# Product Change Notification

**Change Notification #:** 112720 - 00  
**Change Title:** Intel® True Scale Fabric Host Channel Adapter QLE7340CK, Intel® True Scale Fabric Host Channel Adapter QLE7340LCK, Intel® True Scale Fabric Host Channel Adapter QLE7342CK

**QLE734x update regulatory markings for Korea and Canada**

**Date of Publication:** November 18, 2013

Figure 1. Bottom Side View of Board

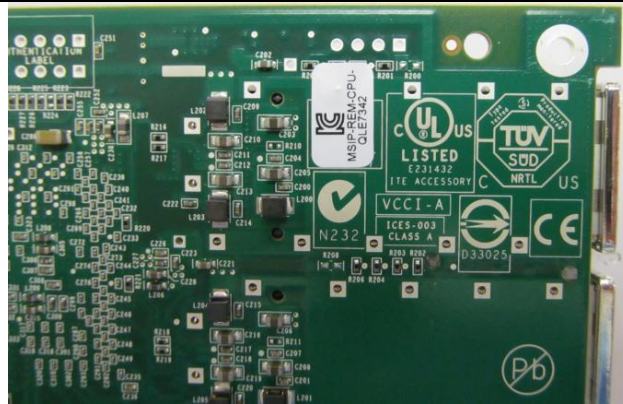
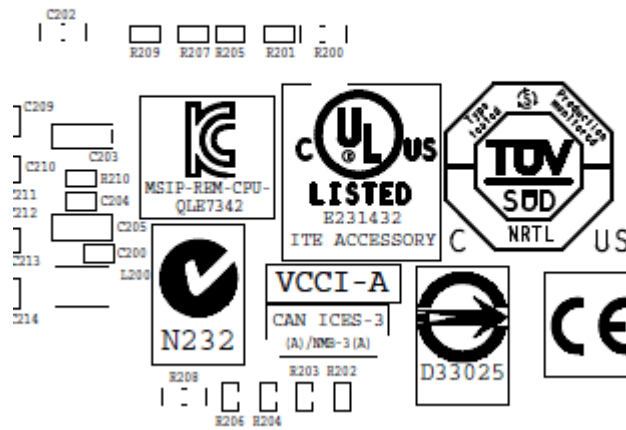
- The Korean Registration number has been changed in the Silkscreen for future builds. Existing products will have a label over the old Korean Marking to implement this change:
  - From: KCC-REM-CPU-QLE7342(A)
  - To: MSIP-REM-CPU-QLE7342
- The Canadian marking has been changed in the Silkscreen for future builds. The existing product marking remains acceptable. Therefore, this change will be phased in over time.
  - From: ICES-003 Class A
  - To: CAN ICES-3 (A)/NMB-3(A)

### Figure 2. Product Documentation/Literature Change

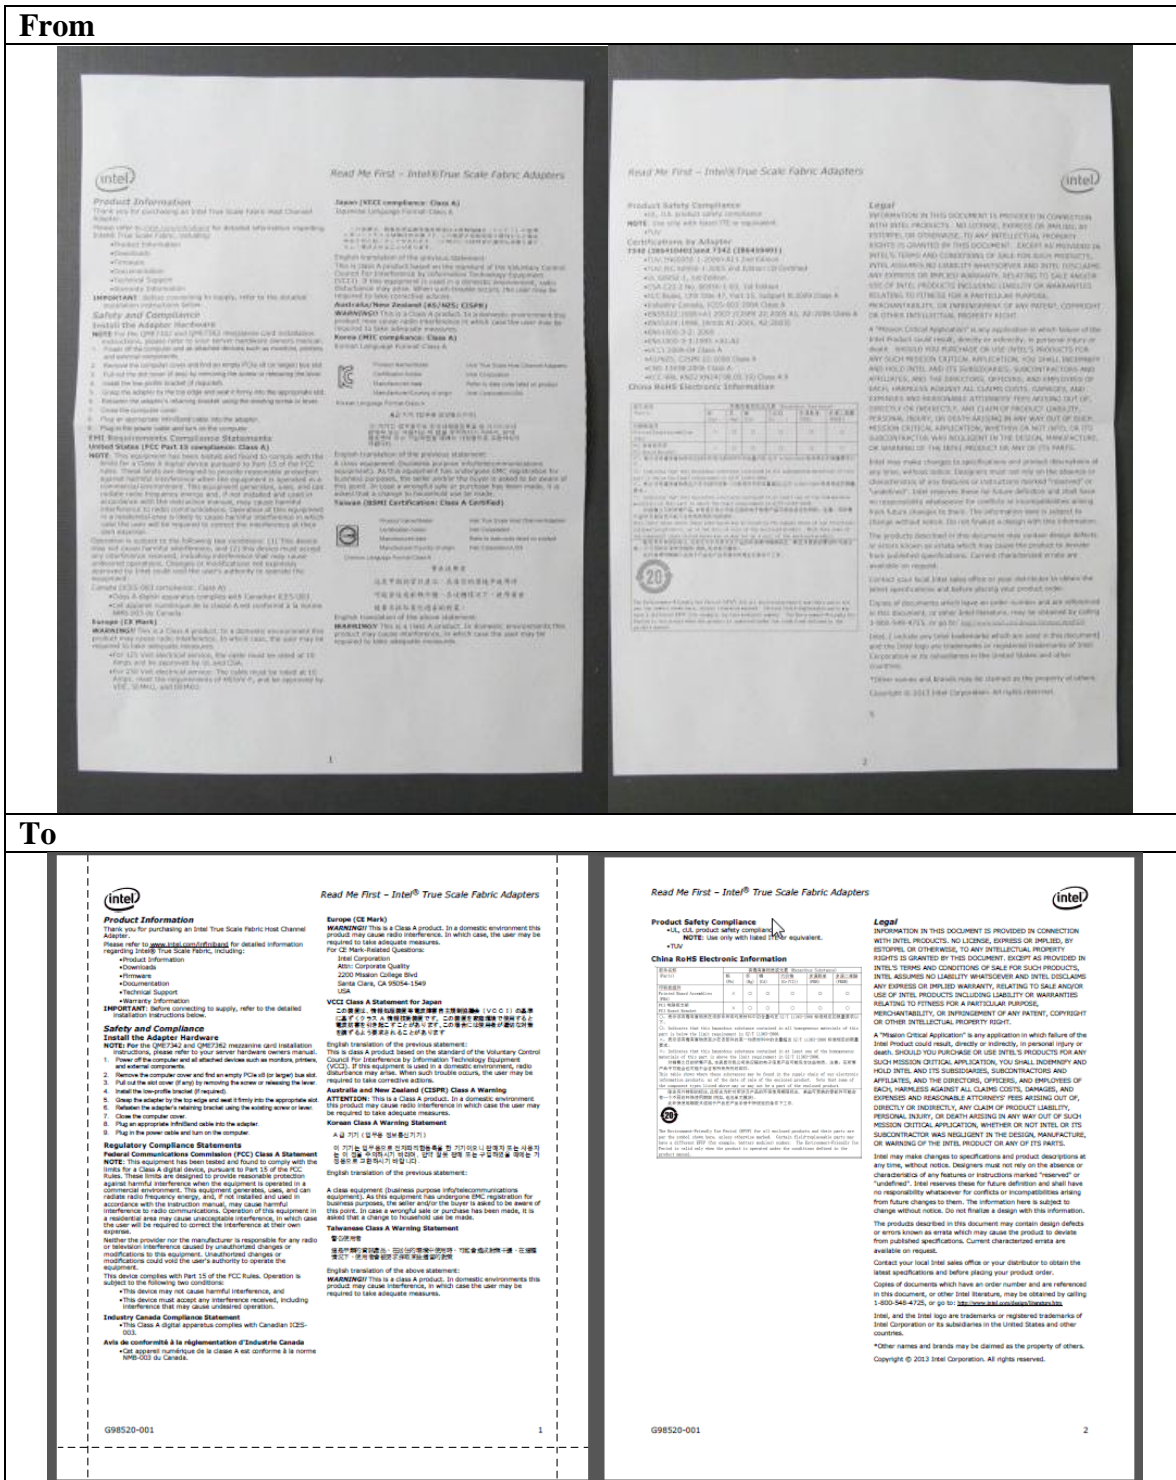
- From: ICES-003 class
  - To: CAN ICES-3 (class)/NMB-3 (class)
- Product documentation:** Updated the Read Me First document to remove the Korean Logo, the Taiwanese Logo, Manufacturer and Country of Origin from the document, as these are not required in this document.

## 1. Removed Korean and Taiwanese logos and Manufacturer Information

**Figure 4. Overpack Carton Label Changes**

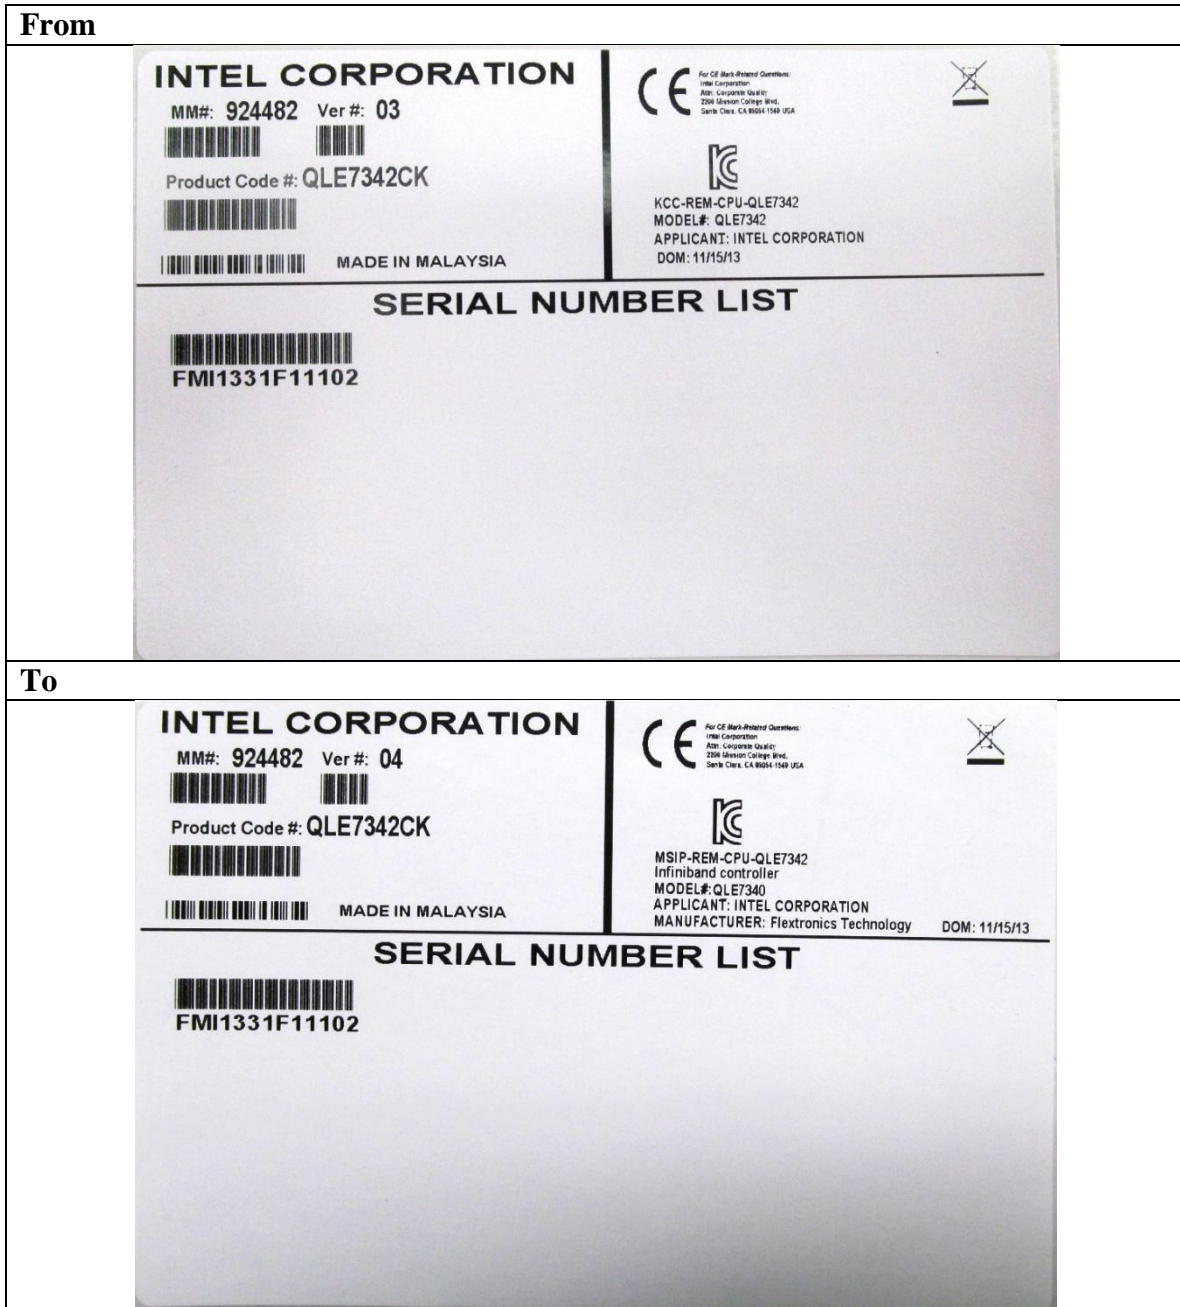
- Updated the Korean KC registration number from KCC-REM-CPU-QLE7342 to MSIP-REM-CPU-QLE7342.
